RE: Quick Quack Car Wash - College Square (P17-073)

Attachment: E-W and N-S Walking Routes on College Square Schematic Plan and Quick Quack Car Wash Overall Site Plan

E-W and N-S Walking Routes on College Square Schematic Plan

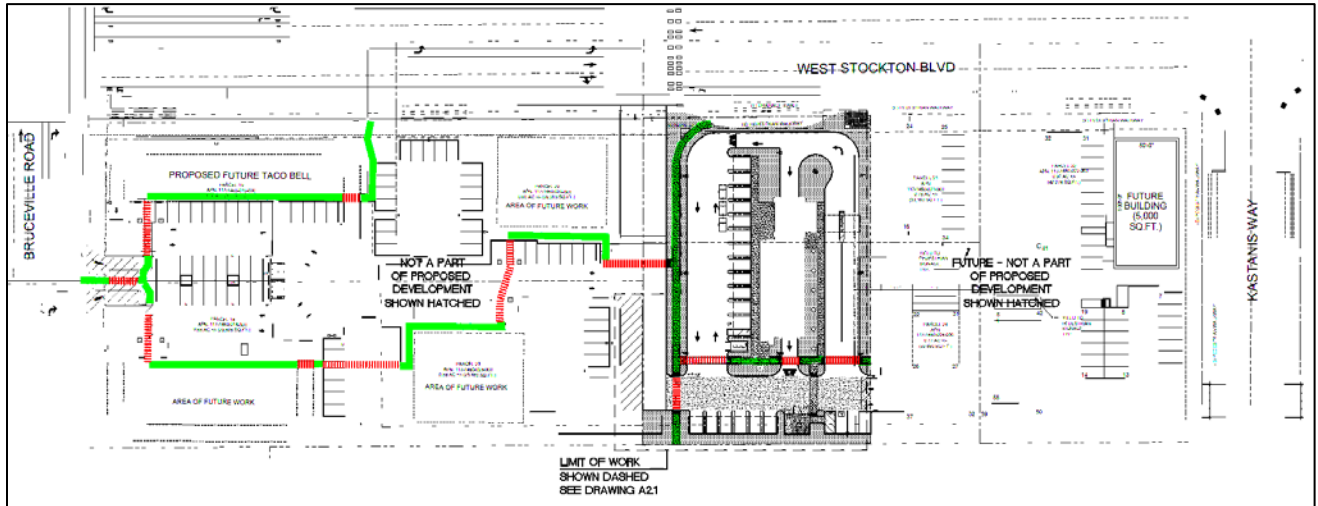
The revised Quick Quack Car Wash College Square site layout interferes with the planned east-west pedestrian travel within College Square South. The 2004 College Square schematic plan provided for a linear pedestrian walkway with crossings of one driveway and two small parking areas in College Square South. The Quick Quack proposal would add three drive aisle crossings just for the car wash operations. Quick Quack combined with College Square South Drive-Through would require ten changes in direction and crossings of one driveway, four drive aisles, two drive-through lanes, and one small parking area. This would be in addition to travel through the future eastern third of the plan area, which at this time is shown as about 80% parking and drive aisles. [See attached drawings.]

More than half of the walking distance between West Stockton Boulevard and the future residential development along the south edge of College Square South is just over 50 feet from the vacuums. The noise from the vacuums along this sidewalk is estimated to be 65 dBA, which is the maximum for noise-sensitive uses such as residential. As such, the vacuum noise will not contribute to a pleasant experience for residents walking to any restaurants, offices or retail in College Square South or the northern College Square shopping center. It could also discourage walking from the residential development planned for south of the project site and create more auto trips to nearby destinations.

In addition to the vacuum noise degrading the north-south walking experience, the east-west walkway proposed in the revised site plan will take walkers about 15 feet from the car wash exit where the blower

noise is estimated to be approximately 80 dBA. Again, the noise will discourage walking trips within and through College Square South and potentially create more auto trips.
